Site Plan Review

PRELIMINARY SITE PLANS

JAX KAR WASH ROCHESTER HILLS

JNRNB2022-0006
PSP2022-0015
Revision 3

C-3.0

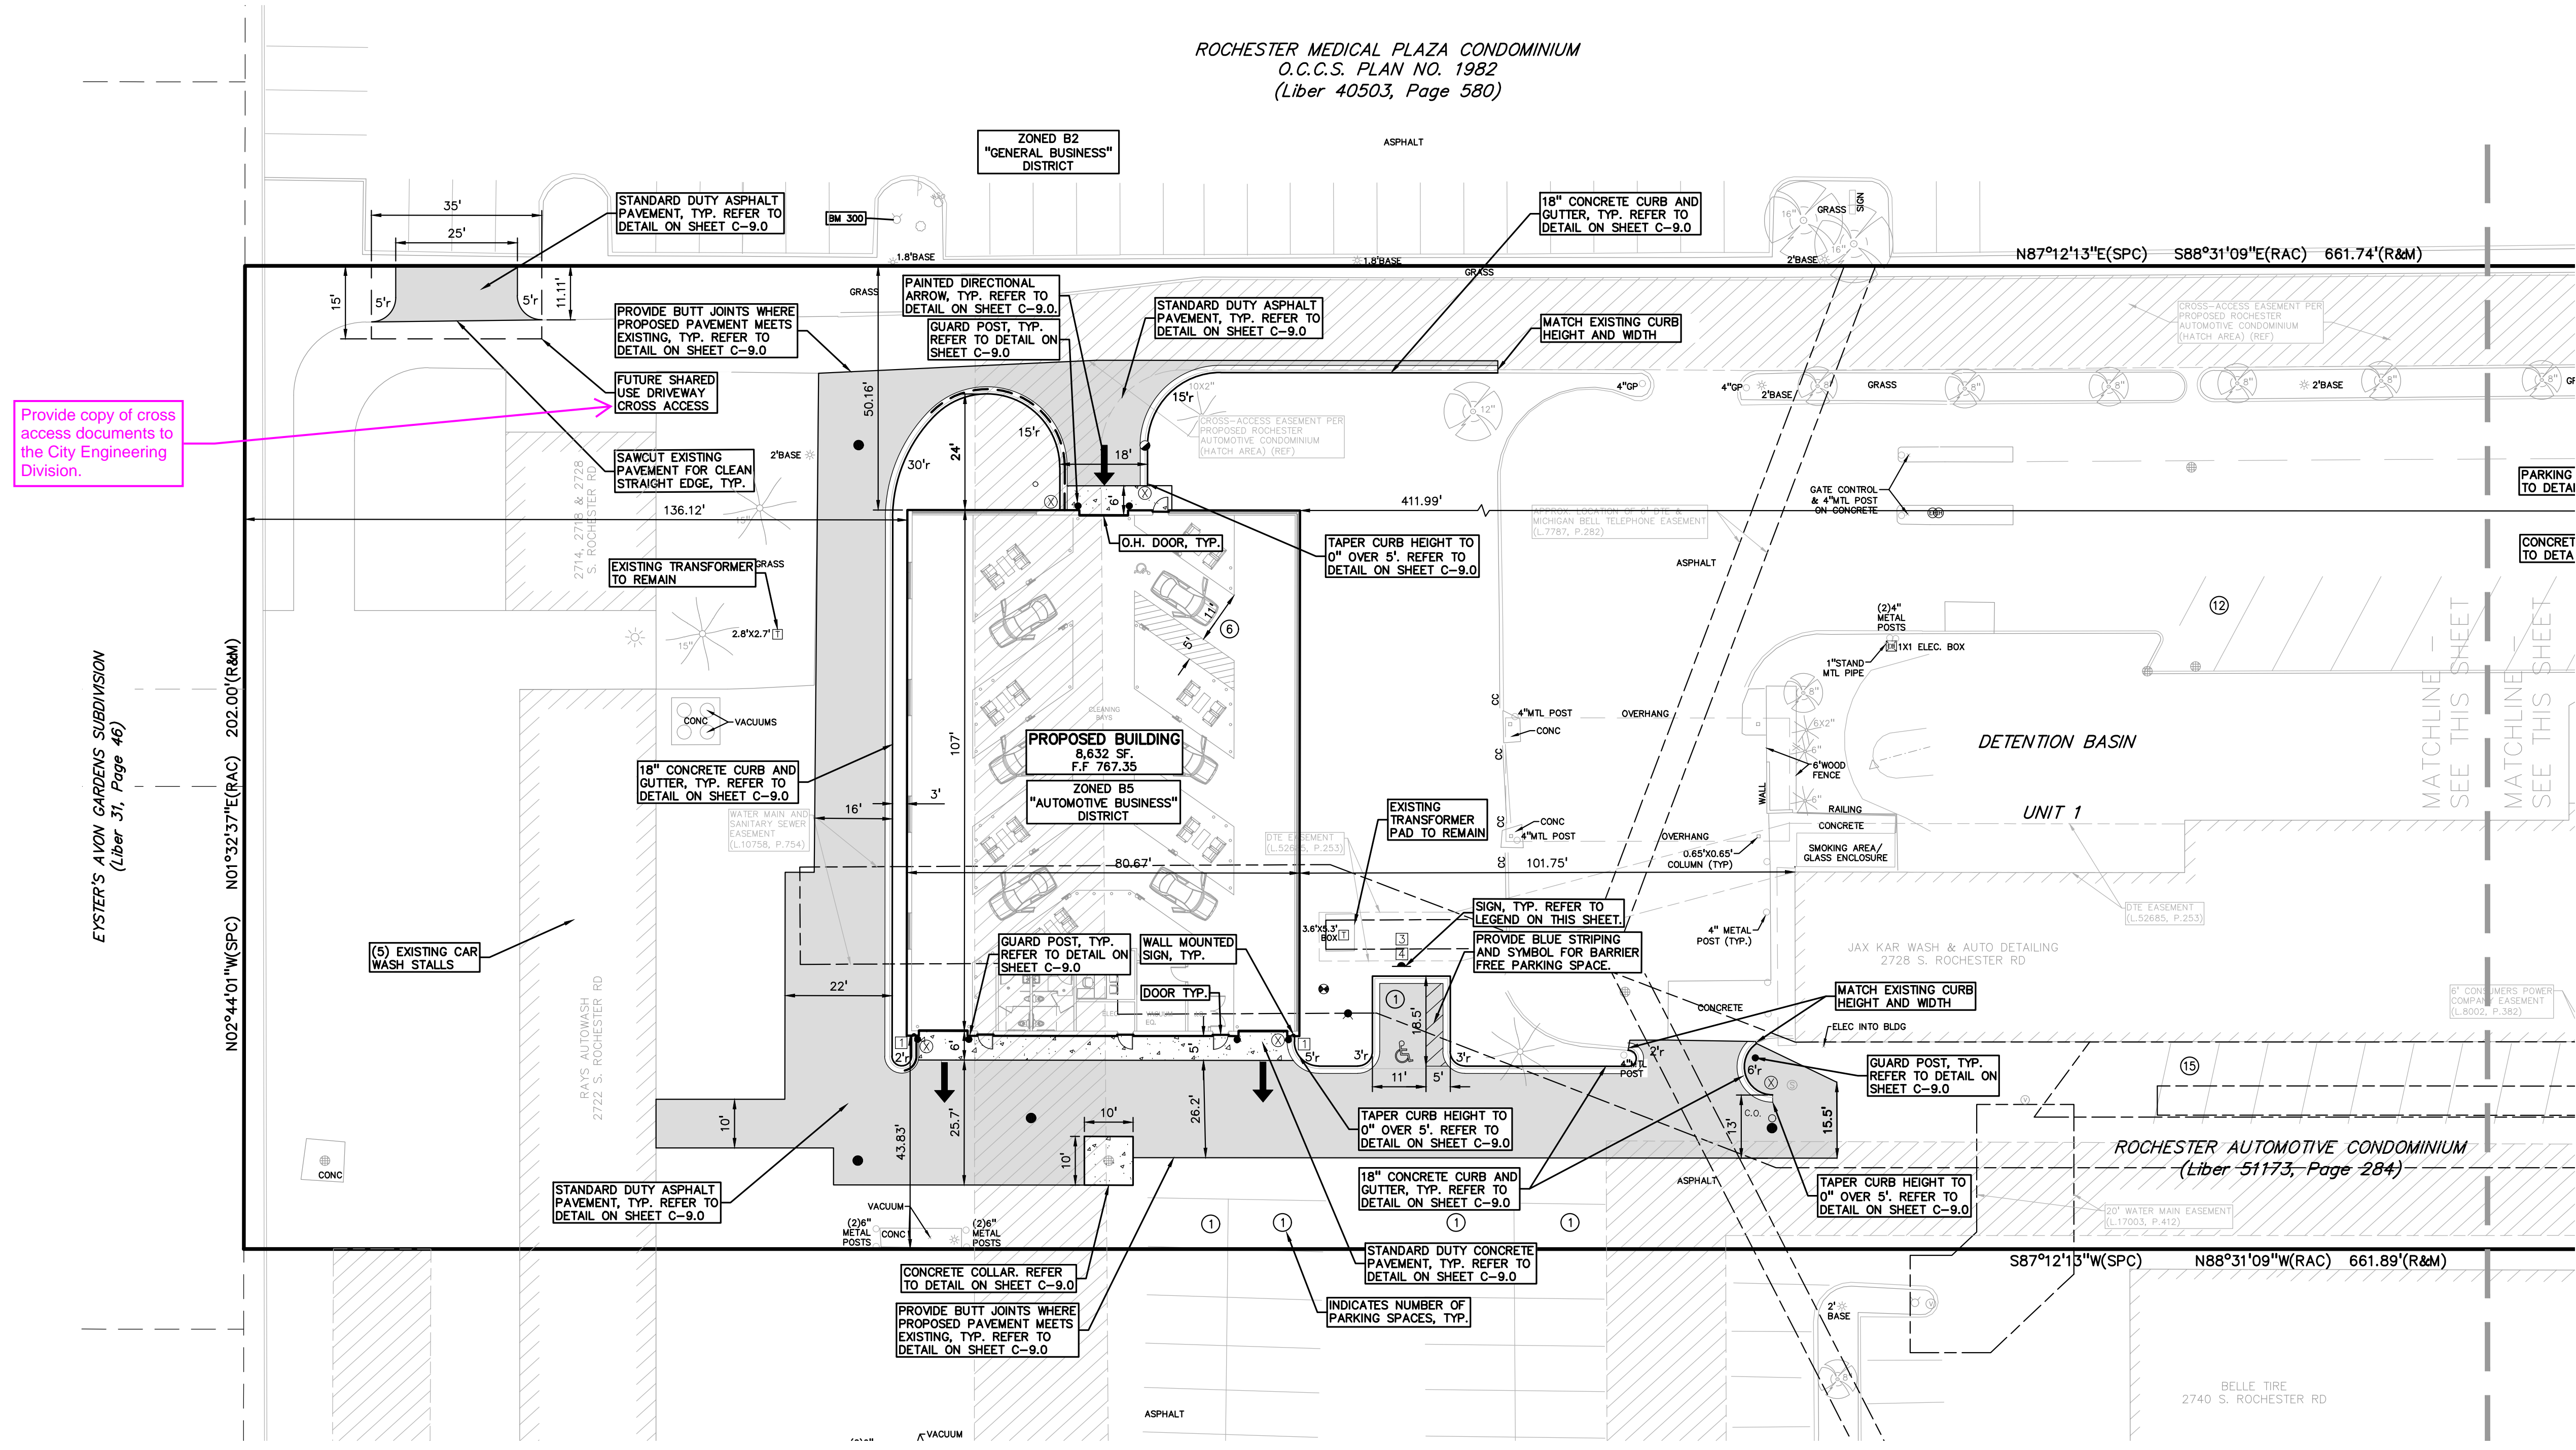
Provide copy of cross access documents to the City Engineering Division.

C-4.0

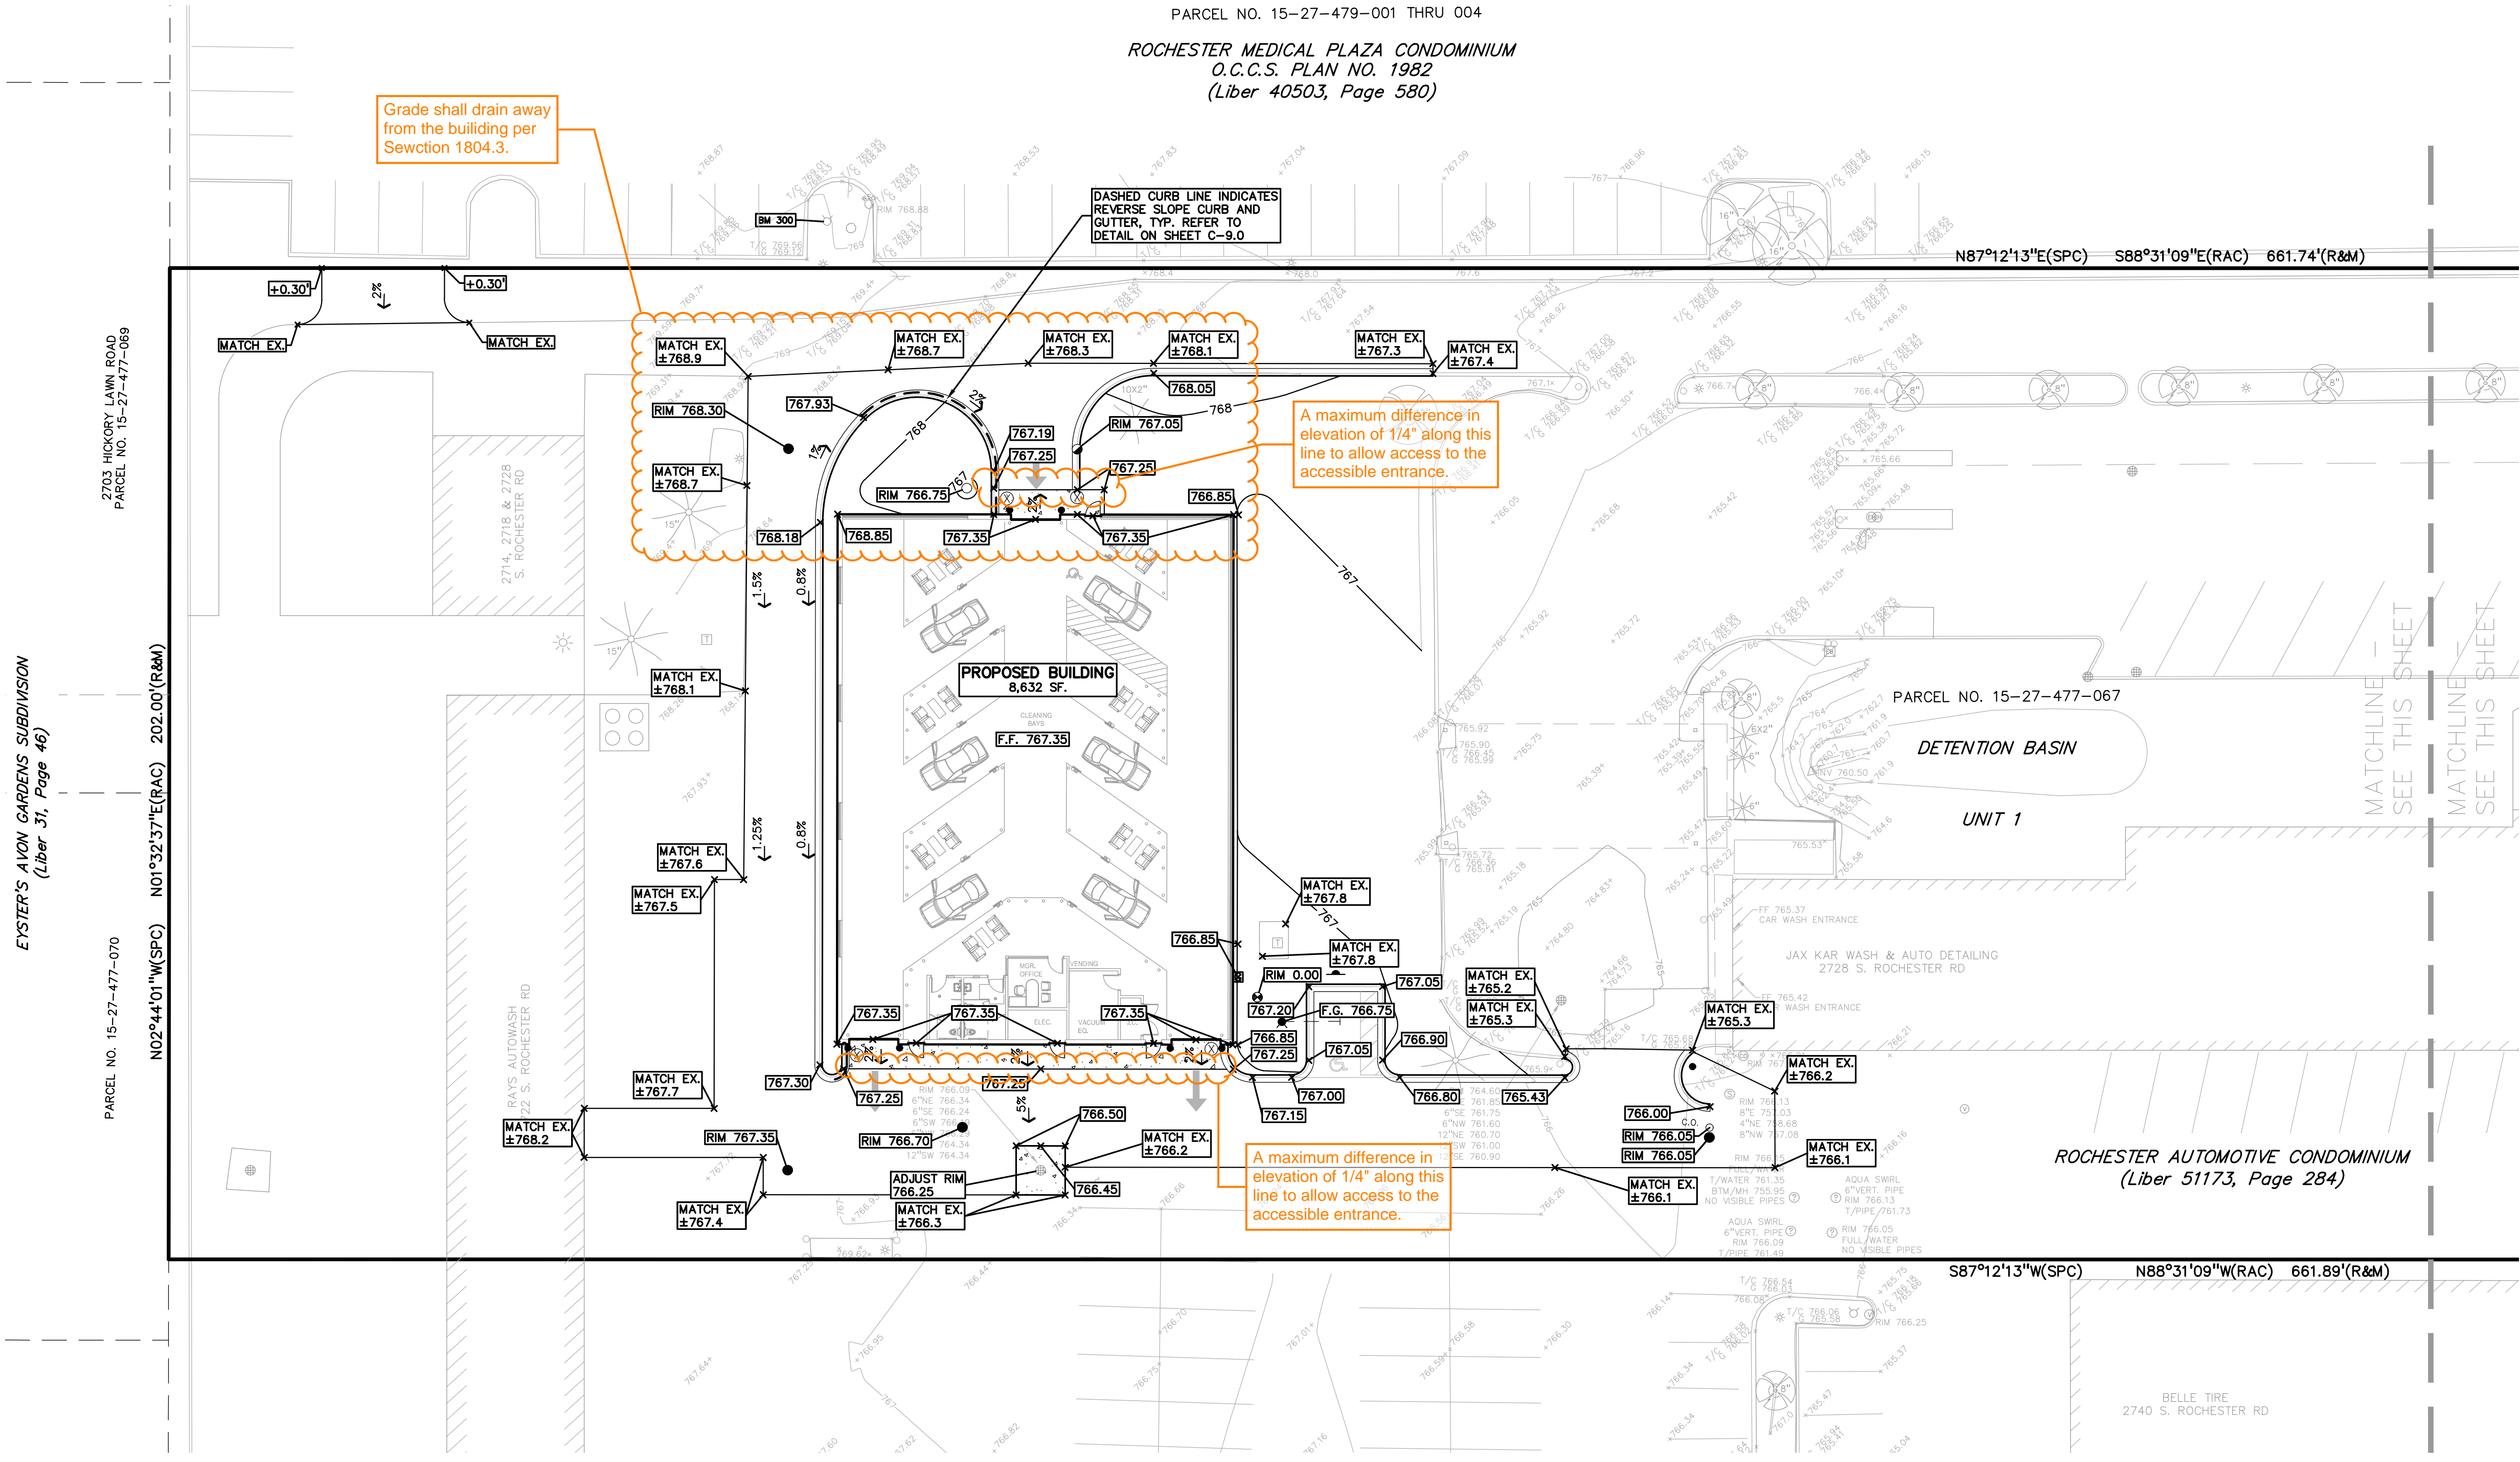
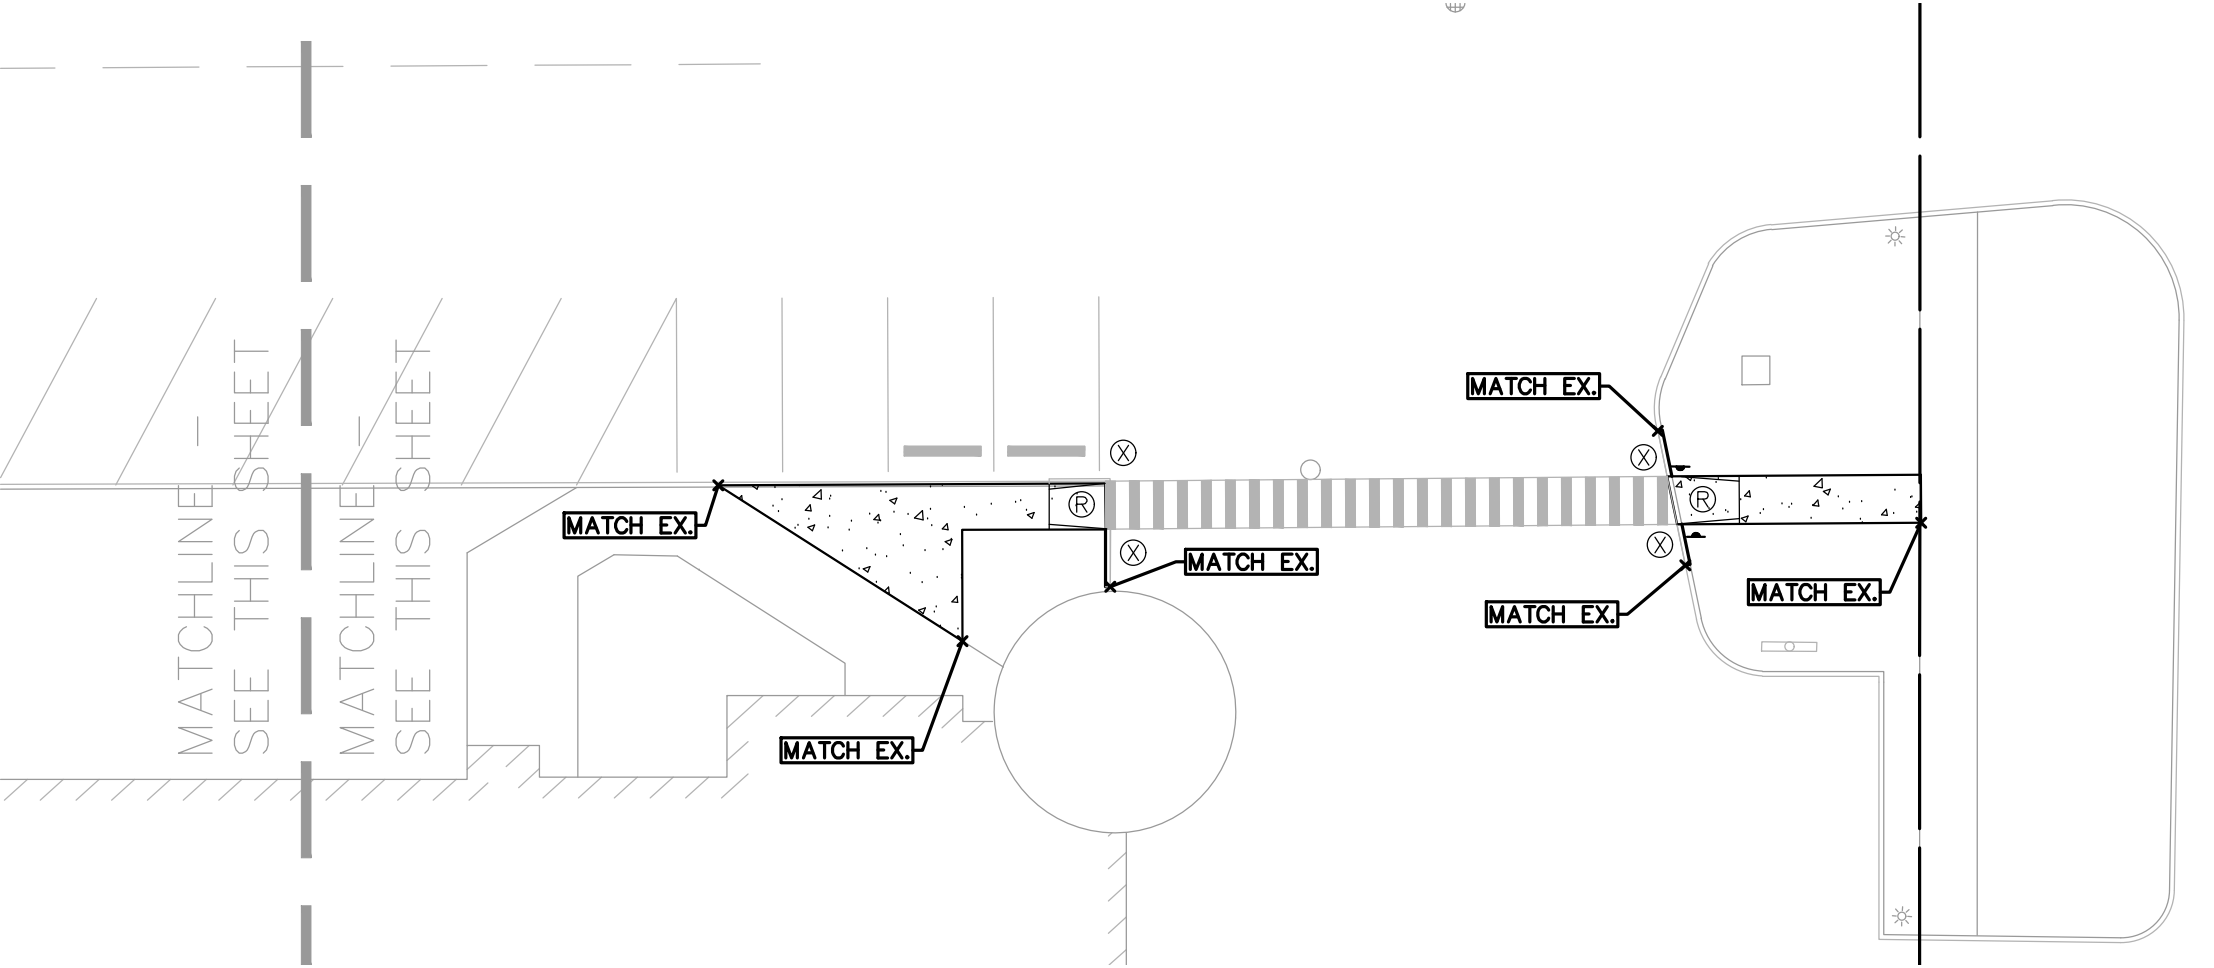
Grade shall drain away from the building per Section 1804.3.

A maximum difference in elevation of 1/4" along this line to allow access to the accessible entrance.

A maximum difference in elevation of 1/4" along this line to allow access to the accessible entrance.
